Item 5.**Development Application: 26-28 Rainford Street, Surry Hills - D/2021/759****File No.:** D/2021/759**Summary**

Date of Submission:	7 July 2021
Applicant:	SJB Planning
Architect:	SJB
Owner:	G Buttery
Planning Consultant:	SJB Planning
Heritage Consultant:	John Outram Heritage & Design
Cost of Works:	\$1,355,200.00
Zoning:	R1 General Residential. The proposed dwelling is permissible with consent within the zone.
Proposal Summary:	<p>The application proposes alterations and additions to the existing former warehouse building for a residential dwelling across four storeys. The proposal includes a mansard style roof addition to the building to approximately the same height as an existing rooftop addition.</p> <p>The application includes a request to vary the height of buildings and floor space ratio development standards. The application proposes a maximum height of 12.37 metres which represents a variation of 37 per cent to the standard, therefore the application is referred to the Local Planning Panel for determination. The application proposes a floor space ratio of 1.87:1 which represents a variation of 7 per cent to the standard.</p> <p>The proposed development was notified

Figure 19: Proposed west elevation. Existing building line shown dashed blue.

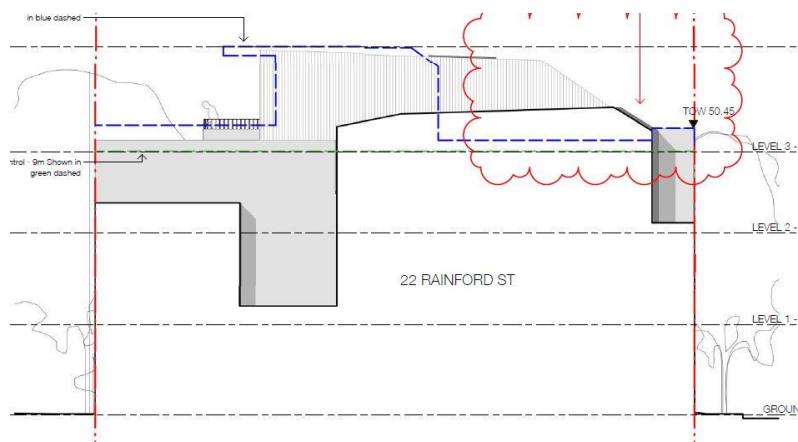
- (a) That compliance with the development standard is unreasonable or unnecessary in the circumstances of the case:
 - (i) The proposal is consistent with the objectives of the height of buildings standard and the objectives of the R1 General Residential Zone.
 - (ii) The existing building has a maximum height of 12.48m. The proposed alteration to the third storey will sit below this height and reduce this non-compliance.

- (iii) The variation to the standard does not contribute to unreasonable impacts in terms of overshadowing, privacy, visual impacts or view loss to adjoining or surrounding properties.

- (iv) The existing building parapet to Rainford Street is to a height of 10.2m exceeds the height control.
- (v) The proposed alterations above the parapet are setback from the front side and rear and the existing building retains its current scale within the streetscape.
